14370
 MADISON, WI
 PHEASANT BRANCH GREENWAY ENHANCEMENT
 CONTRACT NO.: 9517

ACCESS TRANSMISSION SERVICES, LLC
OUTSIDE PLANT CONSTRUCTION
TITLE: FIBER OPTIC CABLE ROUTE
PHEASANT BRANCH CABLE RELOCATE

PHEASANT BRANCH DRAINAGE PUBLIC IMPROVEMENT MAIN PROJECT NO. 57874-0001 MADISON, WI JOB NO. 40-4536-1-24

PROJECT NAME:
CONFLICT REVIEW - PHEASANT
BRANCH GREENWAY
ENHANCEMENT - CITY OF
MADISON - PRJ NO. 14370

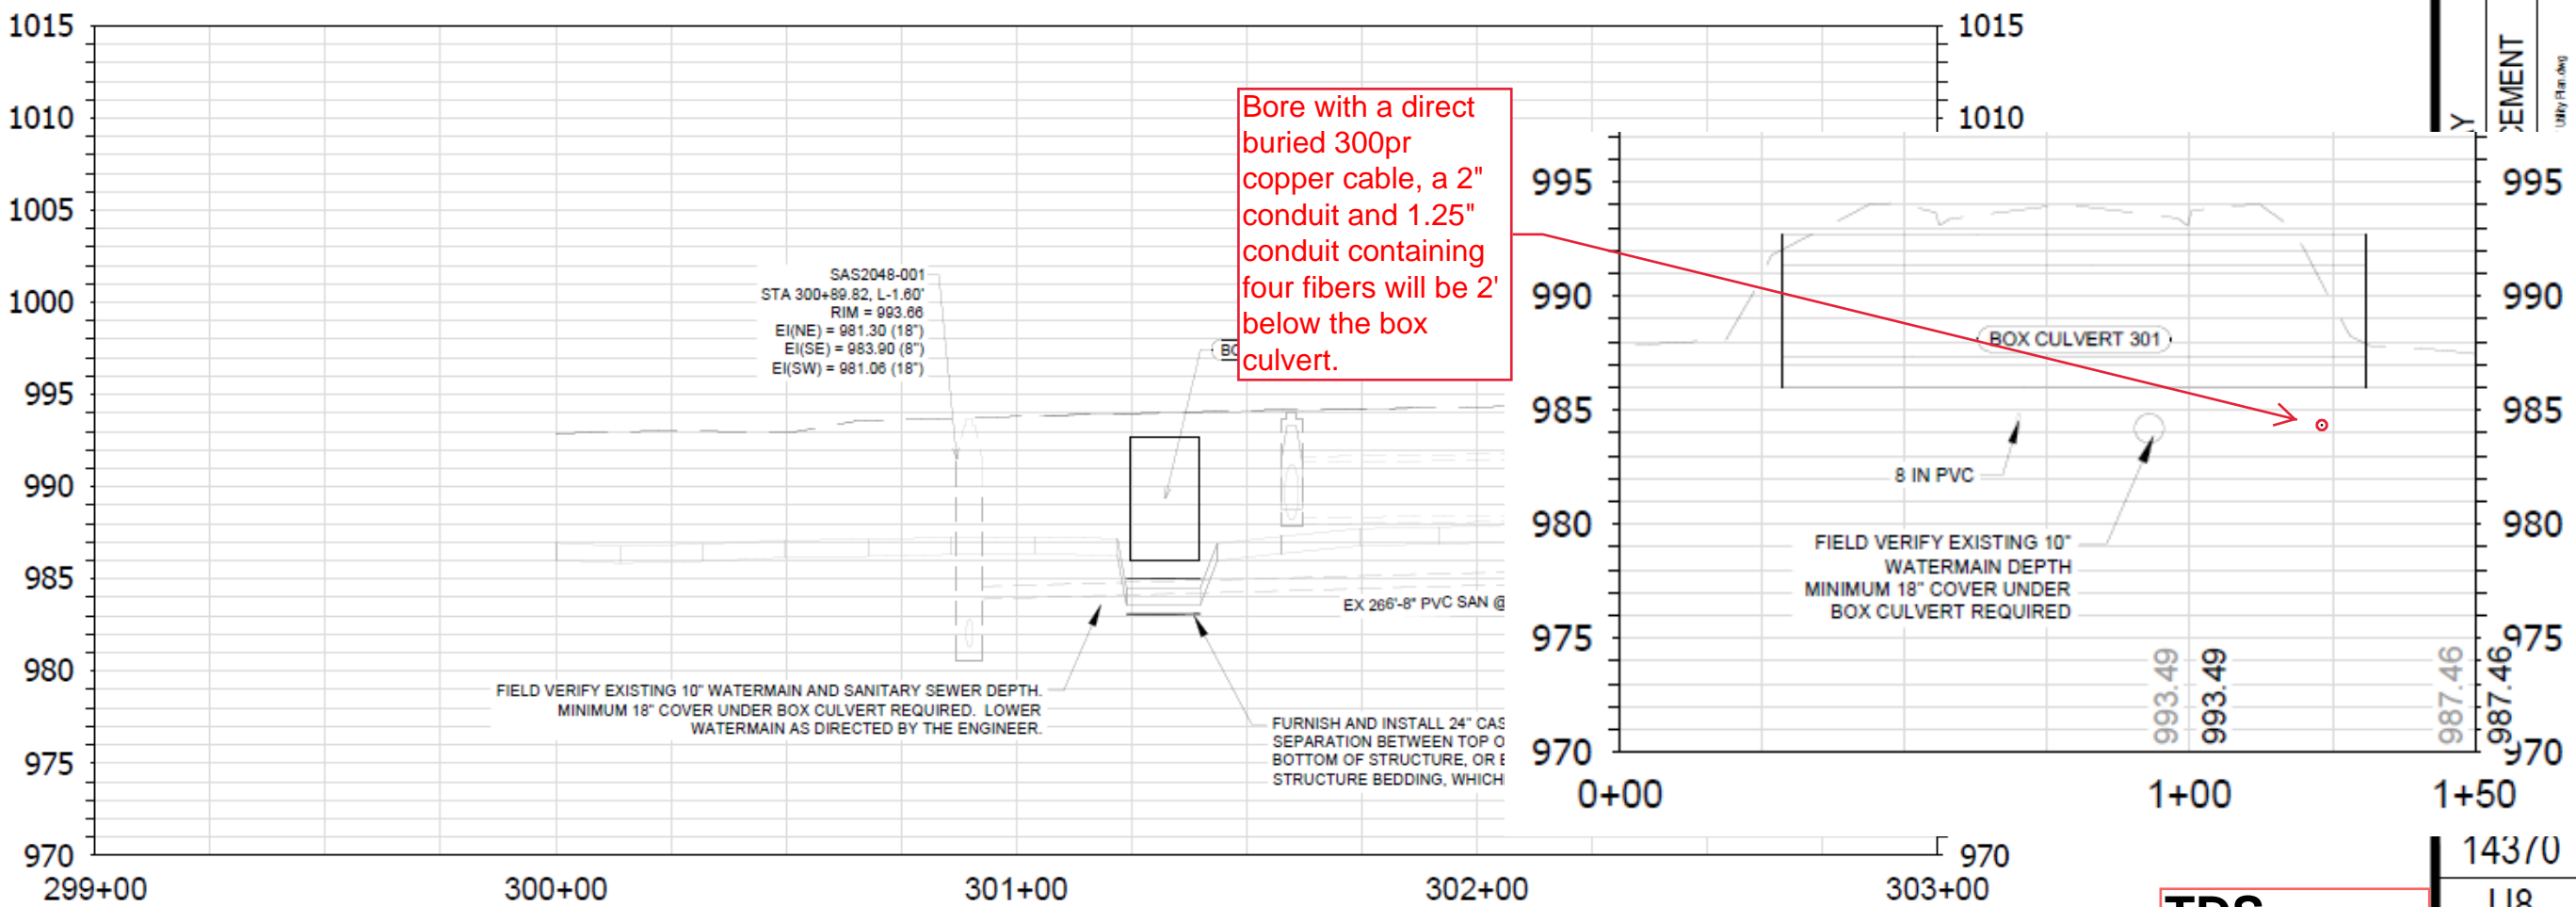
Site 7: Install 2 handholes with splice cases; bore 330' with a direct buried 300pr copper cable, a 2" conduit and a 1.25" conduit; containing 72F fiber, 96F fiber, another 96F fiber and a 24F fiber

Bore with a direct buried 300pr copper cable, a 2" conduit and 1.25" conduit containing four fibers will be 2' below the box culvert.
